**Department of Energy**  
Albuquerque Operations Office  
P.O. Box 5400  
Albuquerque, New Mexico 87185-5400

June 30, 1999

The Honorable John T. Conway  
Chairman  
Defense Nuclear Facilities Safety Board  
625 Indiana Avenue, N.W.  
Suite 700  
Washington, D.C. 20004

Consistent with the Department's implementation plan (98-2 Plan) for the Defense Nuclear Facilities Safety Board's (The Board) Recommendation 98-2, nine of the eleven deliverables due in the month of June are enclosed. One (5.4.1) was previously submitted, and we have also completed one July deliverable early (5.3.2b), which is enclosed. Details addressing the one missed deliverable (5.1.4) will be provided via separate correspondence.

The NEO Change Control process flow is illustrated in Figure 1.

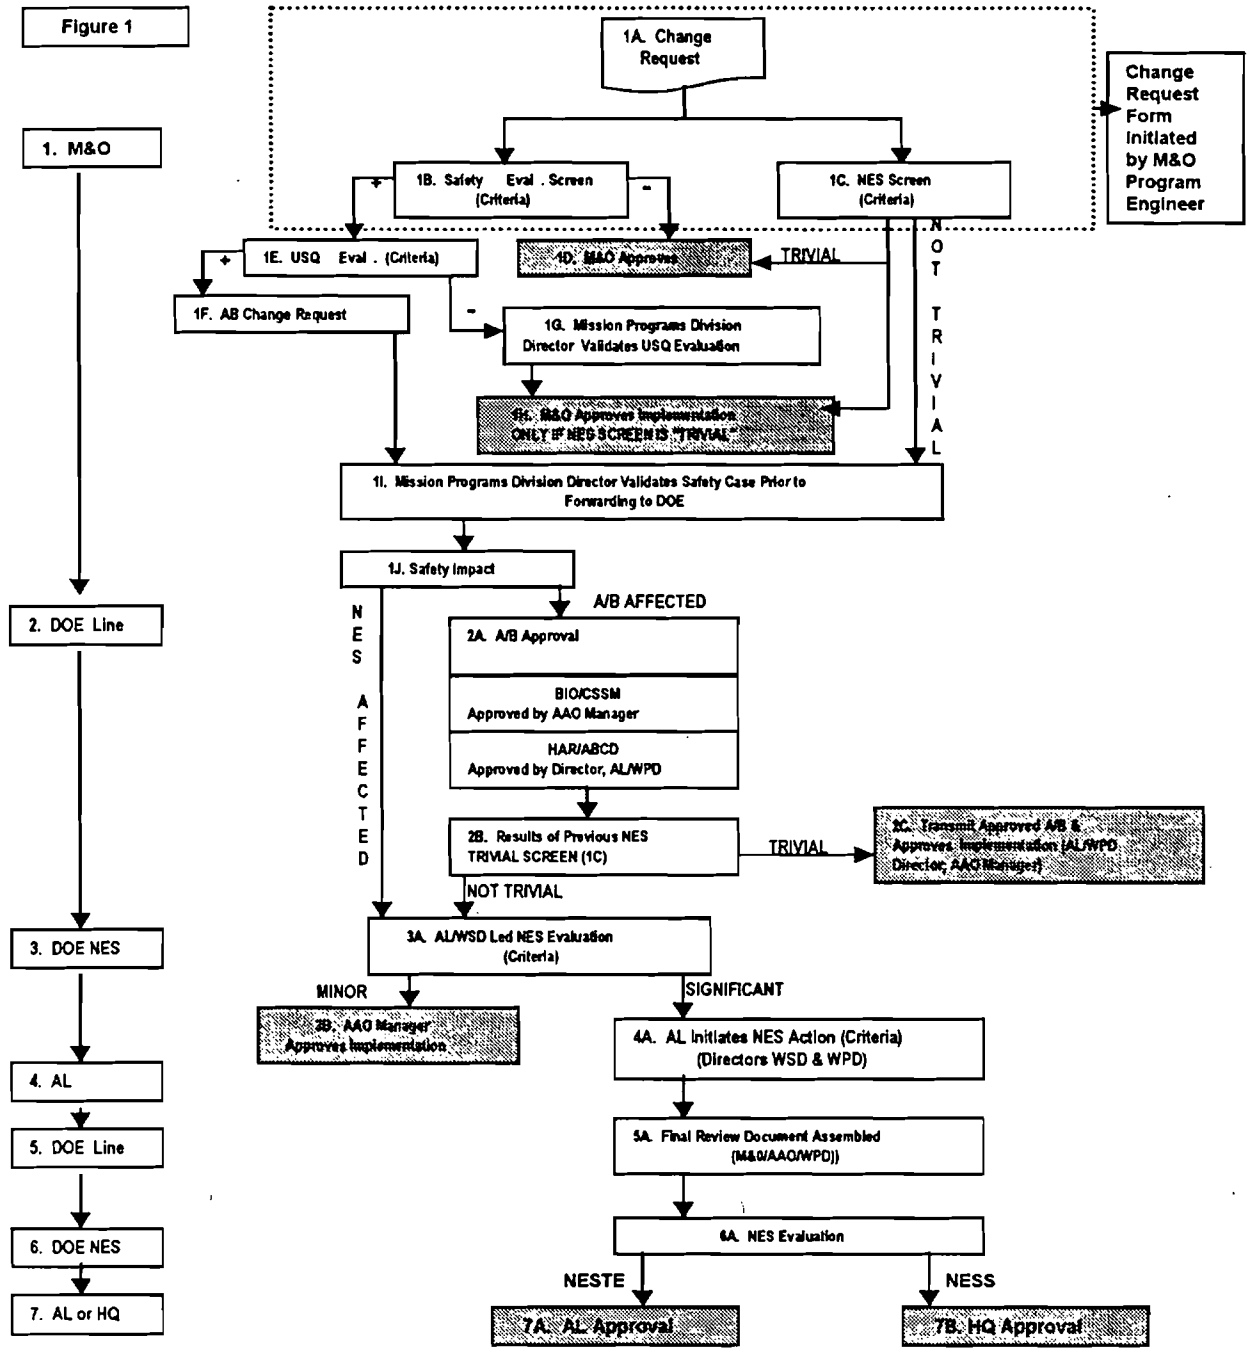
44.	4.c(1)©	Delete the reference to Figure 1 since it is not accurate and provides no real value.
45.	Figure 1	Delete Figure 1 since it is not accurate and provides no real value.
